SUBJECT: NUCLEAR REGULATORY COMMISSION INSPECTION REPORT  
NO. 99901030/2013-201, NOTICE OF NONCONFORMANCE

**U.S. NUCLEAR REGULATORY COMMISSION  
OFFICE OF NEW REACTORS  
DIVISION OF CONSTRUCTION INSPECTION AND OPERATIONAL PROGRAMS  
VENDOR INSPECTION REPORT**

Report No.: 99901030/2013-201

Vendor: Mitsubishi Heavy Industries, Ltd.  
1-1. Wadasaki-Cho 1-Chome, Hyogo-Ku  
Kobe, 652-8585, Japan

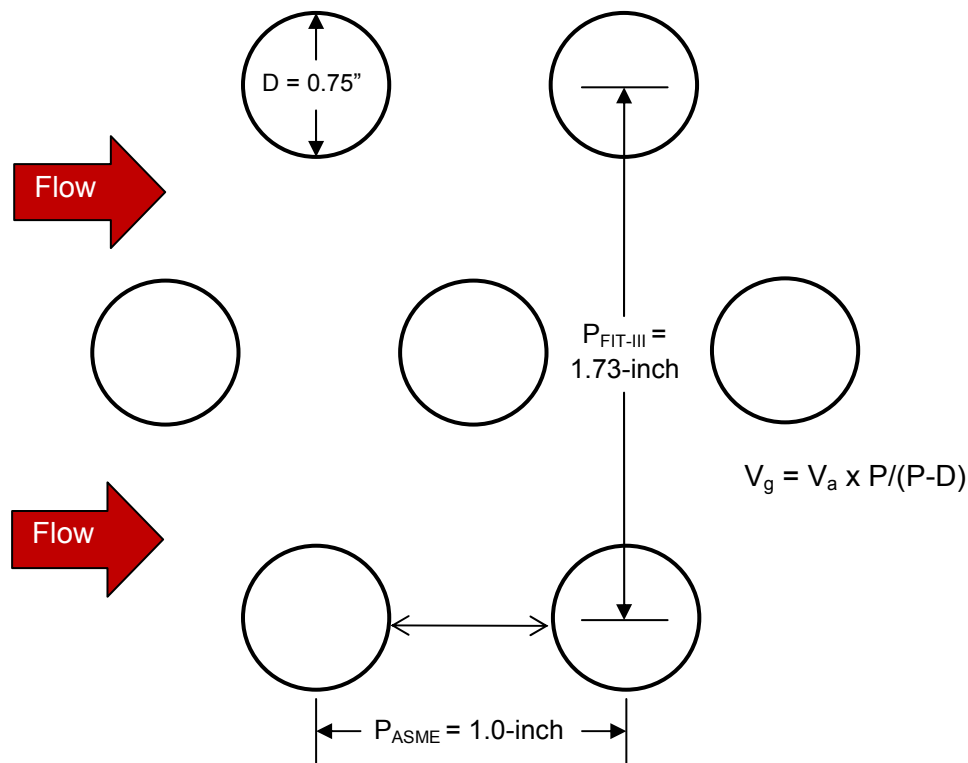
CAR-12-028 was issued May 10, 2012, for using the incorrect fluid elastic velocity as input into the evaluation of FIVATS. Specifically, the SGDS had planned and documented that they had applied the analysis method of American Society of Mechanical Engineers (ASME) Code Section III Division 1, Non-Mandatory Appendix N-1300, "Flow Induced Vibration of Tubes and Tube Banks," in to the evaluation of flow induced vibration of the tubes. Flow velocity "V" used in the analysis is defined as gap velocity between the tubes as shown in the figure below, and the gap of tube arrangement in SONGS RSG should be defined as "P-D." (narrow gap - 1.0 inches). The MHI SGDS applied the different flow velocity which is defined by another gap (wide gap – 1.73 inches).

It is important to note that Takasago performs the thermal hydraulic analysis (FIT-III) for the steam generators and provides the output to MHI SGDS in the form of a spreadsheet containing various technical information, including gap velocities. The spreadsheet information is used for input into the vibration model which is performed by the SGDS group. The velocity output from FIT-III is based on the wide gap, which is different from the gap velocity defined in the ASME code for a triangular array. In order to calculate the gap velocity based on the narrow gap as defined in the ASME code, a post process conversion for the gap velocity was necessary. The SGDS thought that the gap velocities provided by Takasago were the narrow gap, whereas Takasago knew the velocities were the wide gap. The situation which resulted in the use of the wide gap flow velocity in the fluid elastic vibration analysis, which is different from the narrow gap velocity defined in ASME code, was due to inadequate design interface control. The design engineers in SGDS recognized the fluid elastic vibration analysis needed to be performed using the gap velocity based on the narrow gap as defined by the ASME code.

At the time of the design of the SONGS RSGs, the FIT-III code program manual did not provide an explanation or definition of which velocity was provided as an output (based on the wide or narrow gap). Furthermore, the SGDS procurement specification for FIT-III analysis that was provided to Takasago failed to include a clear description of the requirements to output the narrow gap velocity defined in the ASME code.

The Inspection team identified these issues as Nonconformance 99901030/2013-201-01 for MHI's failure to ensure adequate design interface control between the MHI SGDS and the Takasago Research & Development Center related to the thermal hydraulic and vibration analyses used for aspects of the SONGS RSG design. Specifically, the output of the FIT-III thermal and hydraulic code and input to the FIVATS vibration analysis code were not verified to be in accordance with MHI design requirements. MHI failed to convert the wide gap flow

velocity output results from the FIT-III analysis to narrow gap flow velocities needed as input for the FIVATS vibration analysis code.
